ADDENDUM #2

DPW 21239 ISU: PULLING COURTS SIDING AND WINDOW REPLACEMENT POCATELLO, ID NBW#21001

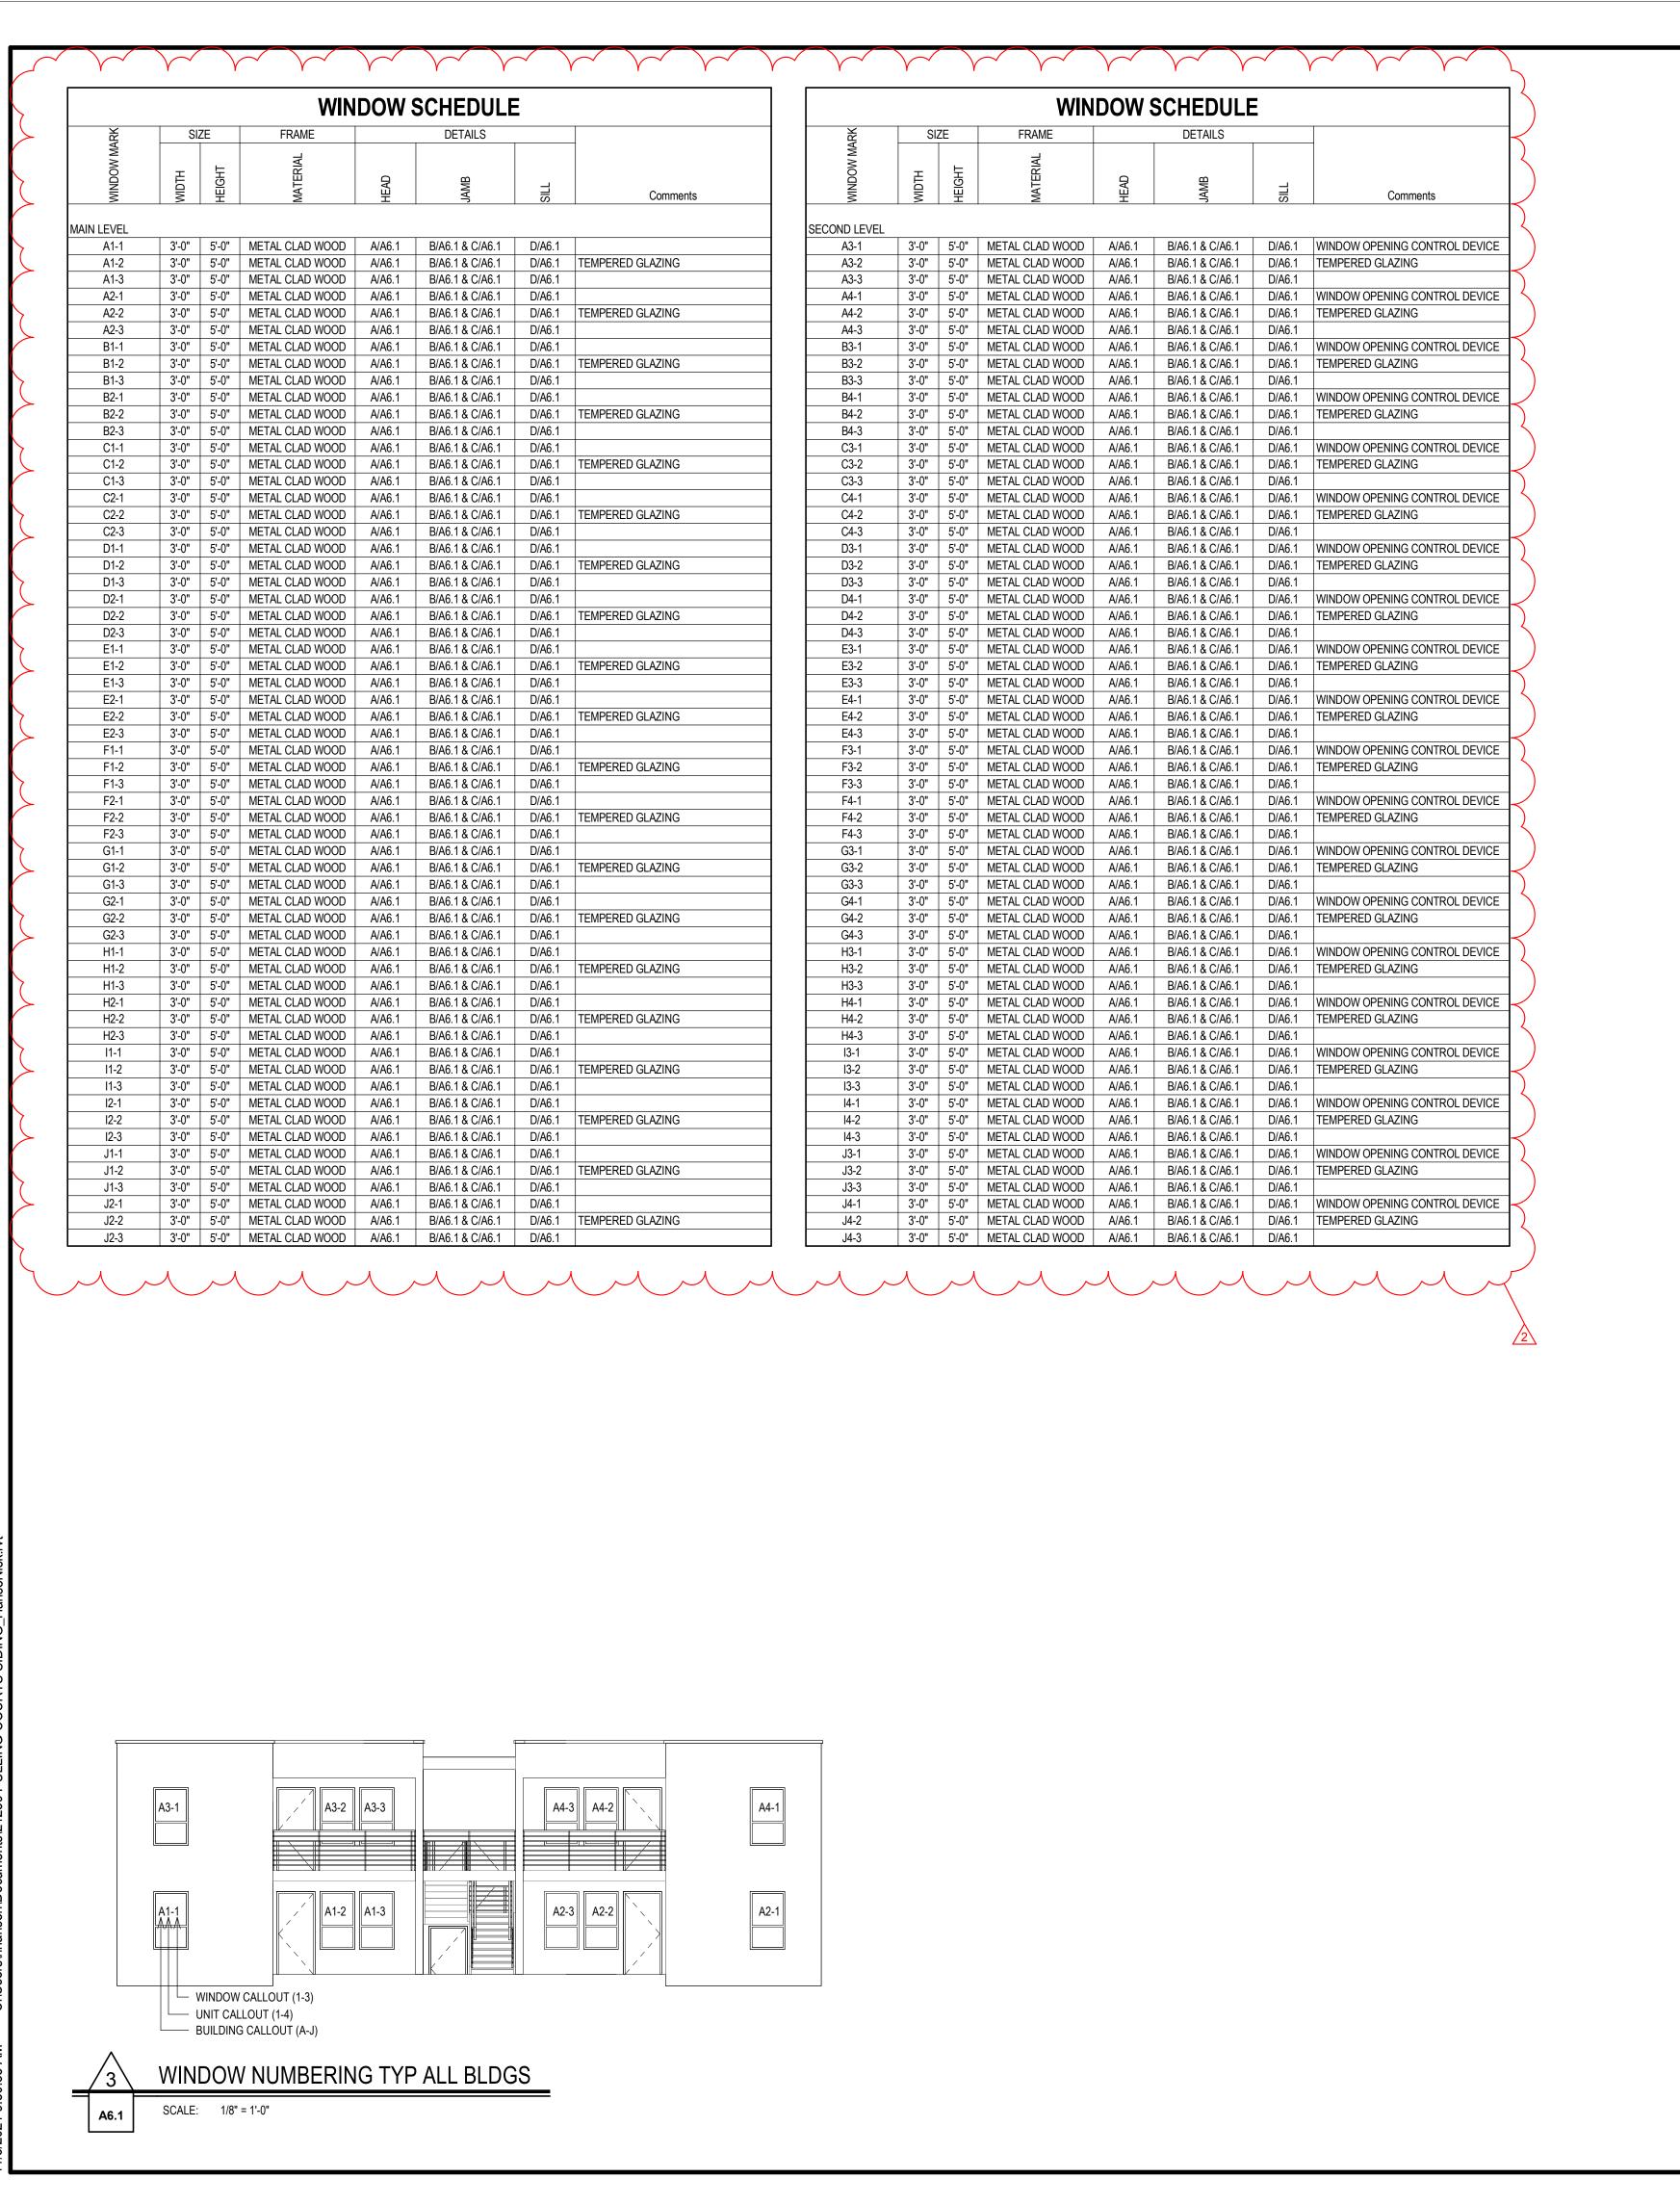
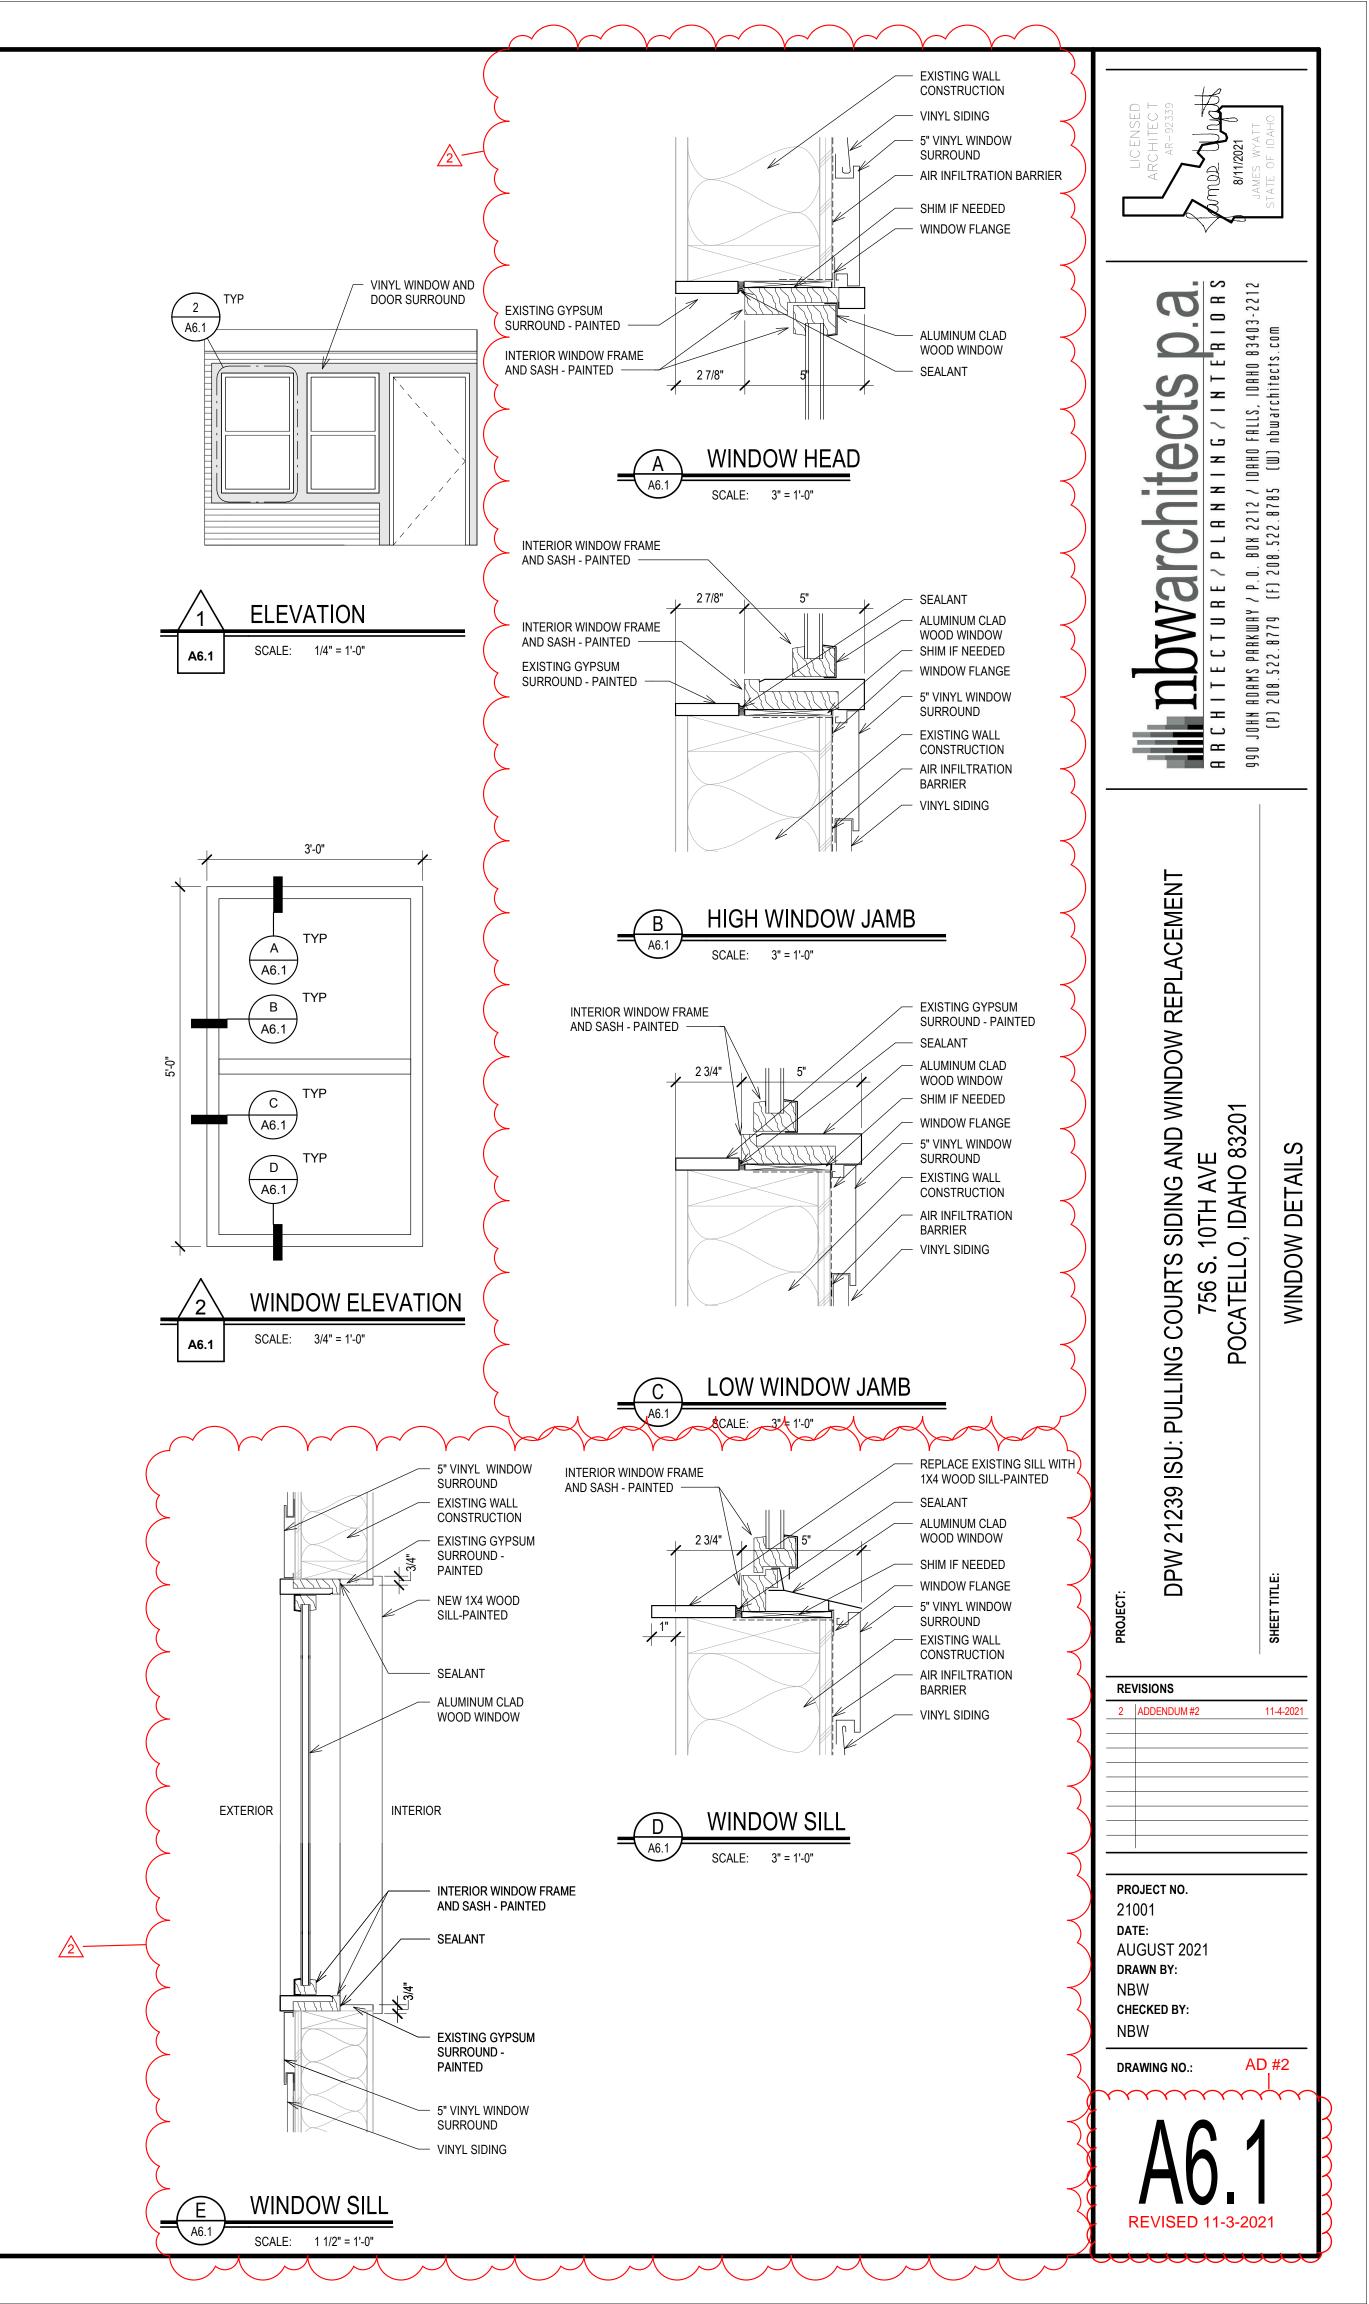
- 1. Sheet A6.1 Details A, B, C, D, and E have been revised to call out painting the interior wood of all new windows.
- 2. Sheet A6.1 Tempered glazing is only to be provided on windows where called for in the window schedule. The window schedule has been updated see attached.
- 3. Specification Section 08 5213 2.3 Glazing This section has been modified to clarify that tempered glass is only required where called for in the window schedule.
- 4. Specification Section 08 5213 2.5 Hardware Section C. has been added for window opening control devices. These devices are required on second floor bedroom windows only see revised window schedule.
